TRANSPORT IMPACT STATEMENT PROPOSED MULTIPLE DWELLINGS DEVELOPMENT 123 – 125 RACECOURSE RD ASCOT

30 JULY 2026
RTeref: 25279

This report is an amended version of the one submitted as part of the Development Application and responds to transport-related matters raised by Council in their Information Request dated 14 April 2026. Brief responses to the matters are provided below and throughout the report.

FIGURE 4.11- 99TH PERCENTILE VEHICLE MANOEUVRING (ACCESS)

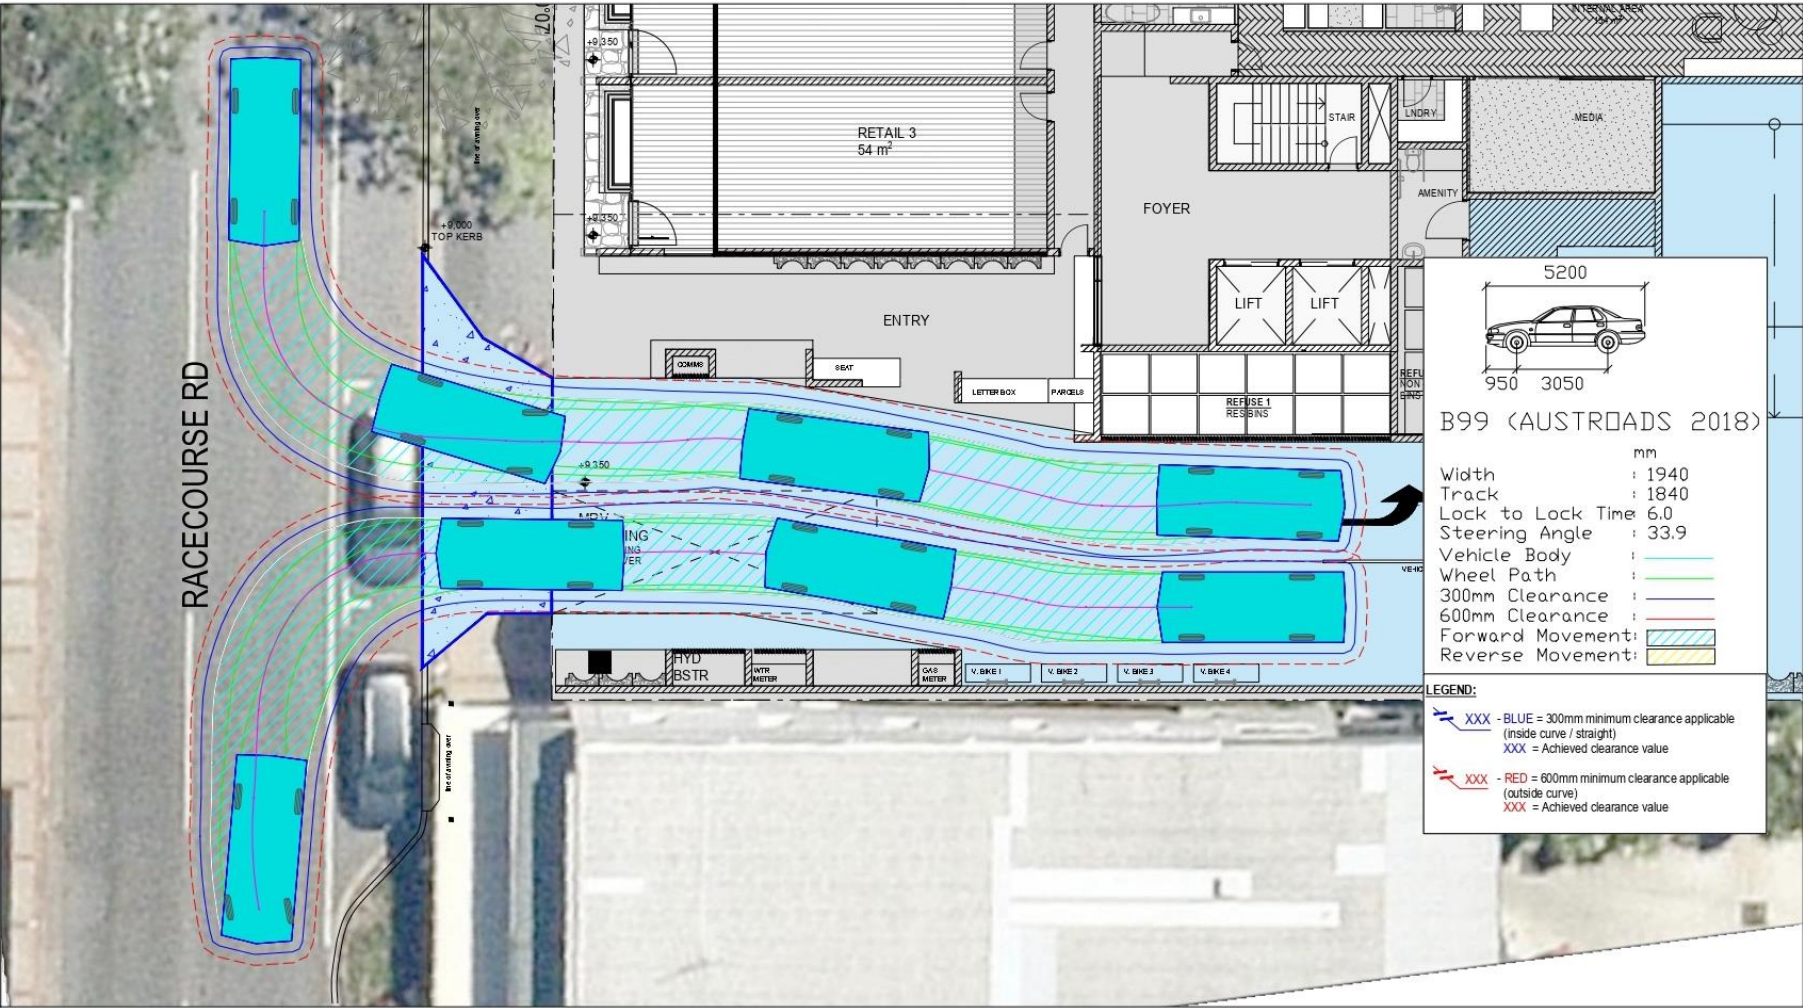
- a. *Submit revised plans providing a standard B2 driveway splay on the southern side of the crossover.*
 - b. *Submit revised plans showing a 2.0m (width) x 5.0m (depth) sight splay on the exit site of the driveway crossover.*

- a. Revised plans provide a standard B1 driveway splay on the southern side of the crossover. As demonstrated in Figures 4.11, 6.1 and 6.2, the revised access arrangement allows the relevant design vehicles to safely exit the site.
- b. Revised plans provide a 2.0m wide x 5.0m deep pedestrian sight splay on the exit side of the driveway crossover.
- c. The service bay dimensions are shown in Figure 4.1.
- d. Updated RPEQ-certified swept path plans demonstrate that the RCV can safely enter and exit the site without conflict with the bus zone, parked vehicles, existing kerb build-out or awning support at 121 Racecourse Road.

FIGURE 5.2 – PROPOSED LINE MARKING AND SIGNAGE PLAN

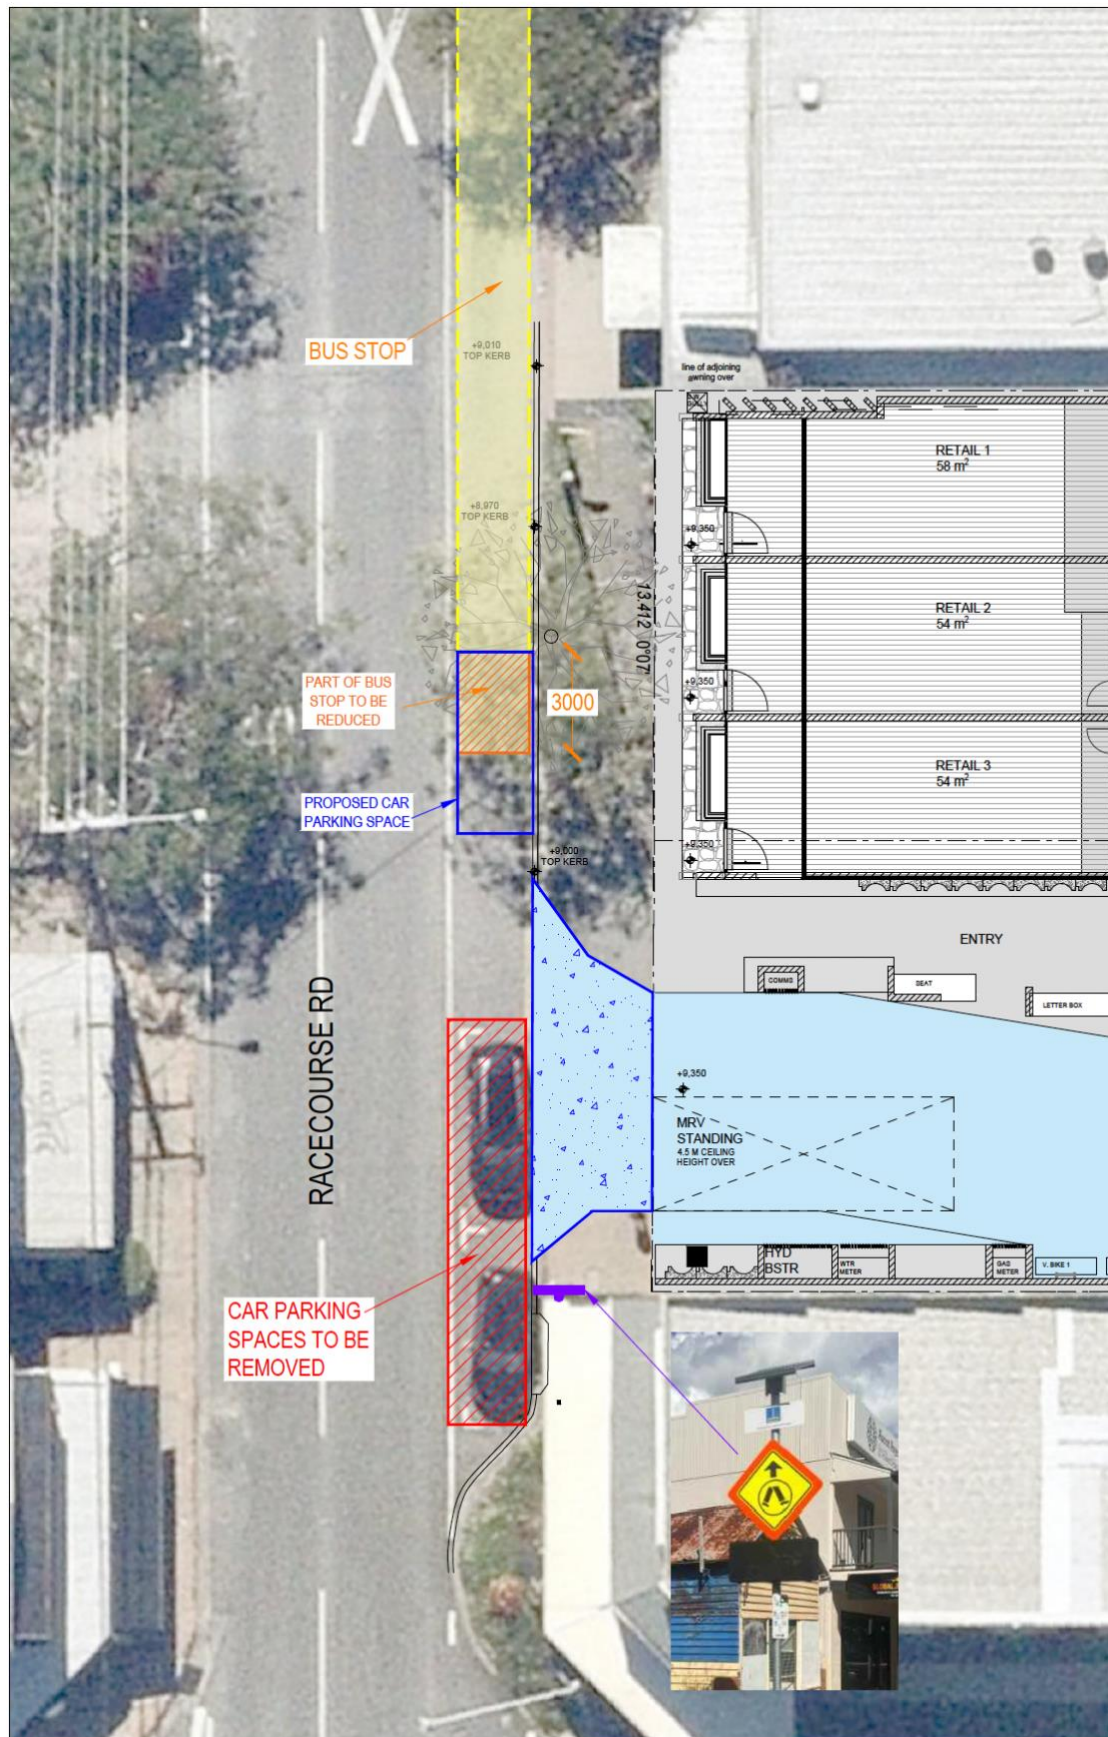
- 13) The site frontage currently accommodates a bus zone, metered on-street car parking spaces, and signage. A signage and pavement marking plan has not been submitted to demonstrate how the existing assets would be maintained. An assessment to determine a suitable location for the existing metered on-street car parking spaces to be relocated as part of this development is required to demonstrate compliance with PO3 of the TAPS code and TAPS planning scheme policy.**

- a. Submit a signage and pavement marking plan signed by an RPEQ to demonstrate how existing kerbside assets would be maintained following the proposal and in conjunction with the proposed driveway crossover; in accordance with PO3 of the TAPS code.**

- b. Demonstrate a suitable location (or locations) which would allow for the existing metered on-street car parking spaces to be relocated to.**
 - c. The proposed signage and pavement marking outcomes are to be carried over to the revised proposed swept path plans to demonstrate how safe access and manoeuvring would be maintained.**

- a. A revised RPEQ-certified signage and pavement marking plan has been prepared, as shown in Figure 5.2, showing the proposed vehicle crossover, revised bus stop extent, proposed replacement kerbside parking space and relocation of the existing pedestrian warning sign to the southern side of the crossover.
- b. As shown in Figure 5.2, the proposed crossover requires the removal of two (2) existing kerbside parking spaces. A replacement parking space is proposed immediately north of the crossover, adjacent to the revised bus stop extent.
- c. A swept path assessment has been carried out, as shown in Figure 5.3, demonstrating that a bus can safely depart the revised bus stop while a vehicle is parked within the proposed replacement parking space. The assessment confirms that the revised kerbside arrangements maintain safe access and manoeuvring.

FIGURE 6.2 –MEDIUM RIGID VEHICLE (MRV) MANOEUVRING

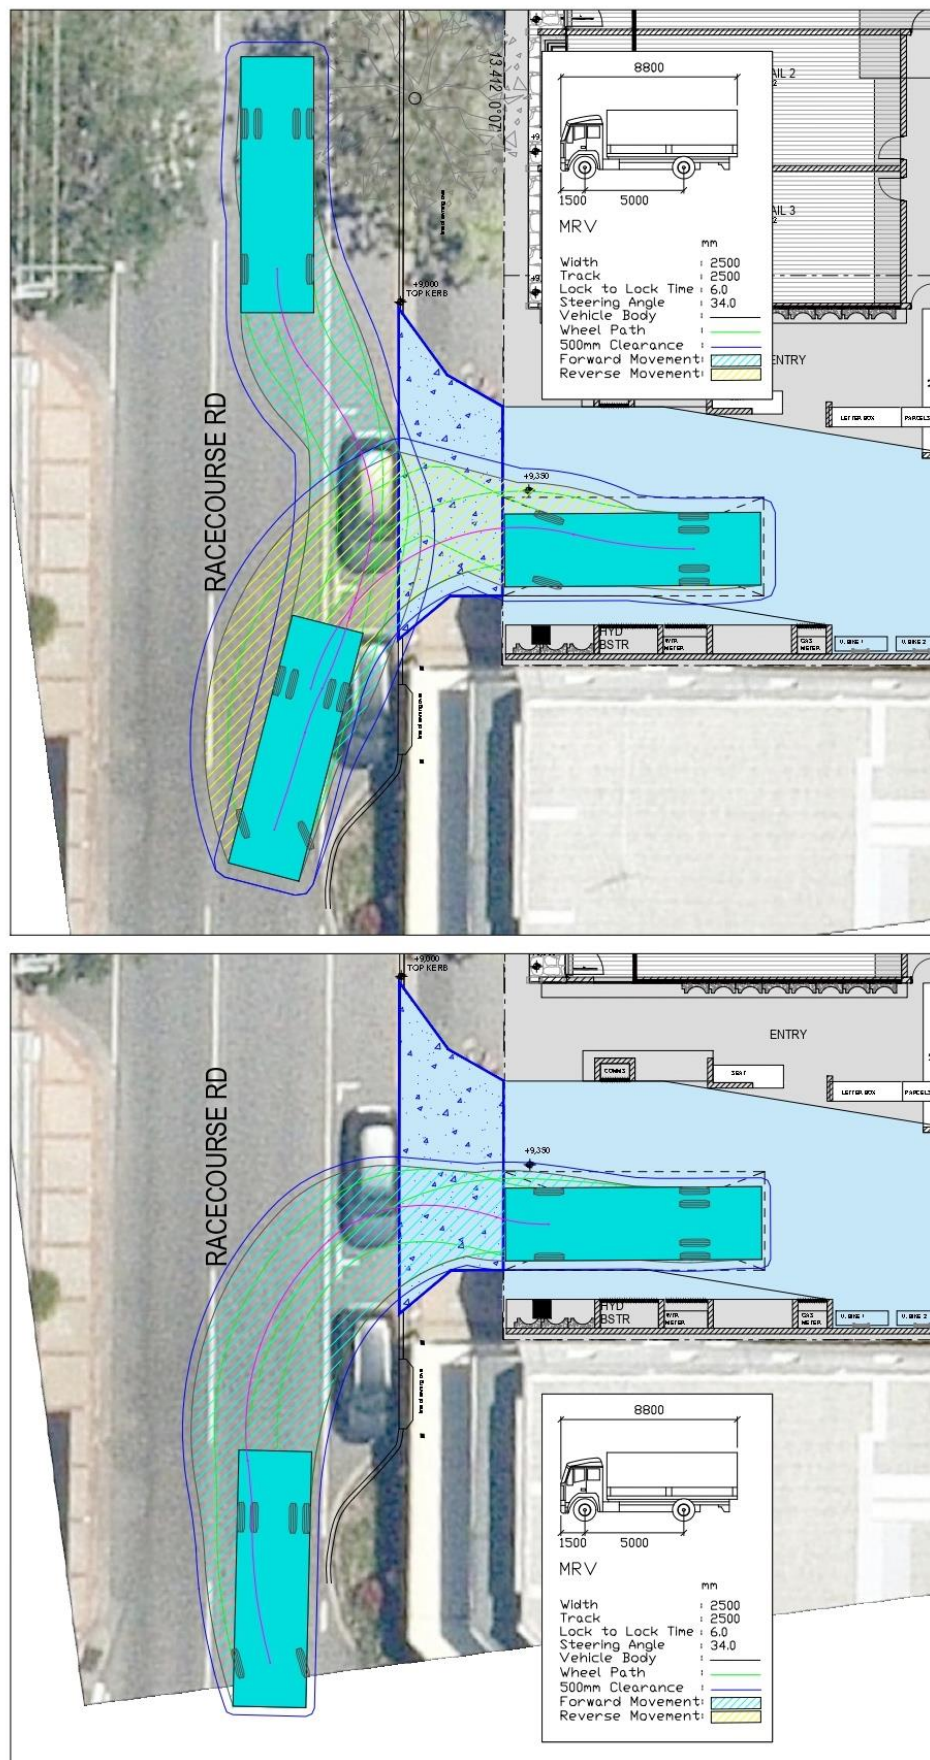
- c. *Submit revised ground level plans which accurately show dimensions for the widths provided throughout the servicing areas on the ground level.*
 - d. *Submit revised RPEQ certified swept path plans showing that the clearance envelope for RCV movements into and out of the site which does not conflict with any obstructions including but not limited to the bus zone, parked cars, the existing kerb build out and awning support for 121 Racecourse Road.*

- a. *Provide an updated RPEQ endorsed swept path analysis demonstrating a RCV as per BSD 3008-2 can safely and efficiently service the site. The swept path must utilise a 6s lock to lock time and a kerb-to-kerb turning radius of 9.757m.*

- b. *Demonstrate the entire two-way aisle/carriageway where trafficked by the RCV has a minimum width of 6.5m.*
 - c. *Ensure the revised RPEQ endorsed swept path analysis does not show any conflict between the RCV manoeuvring area and any potential obstructions such as vehicle parking, the bus loading zone, signage, and the existing kerb build out and awning support within the adjacent frontage of 121 Racecourse Road.*

- a. An updated RPEQ-endorsed swept path analysis has been prepared using the BSD 3008-2 RCV, a 6-second lock-to-lock steering time and a 9.757m kerb-to-kerb turning radius.
- b. The revised layout provides a minimum 6.5m-wide two-way aisle along the full RCV travel path.
- c. The swept path analysis demonstrates clearance from on-street parking, the bus loading zone, signage, the existing kerb build-out and the awning support at 121 Racecourse Road.
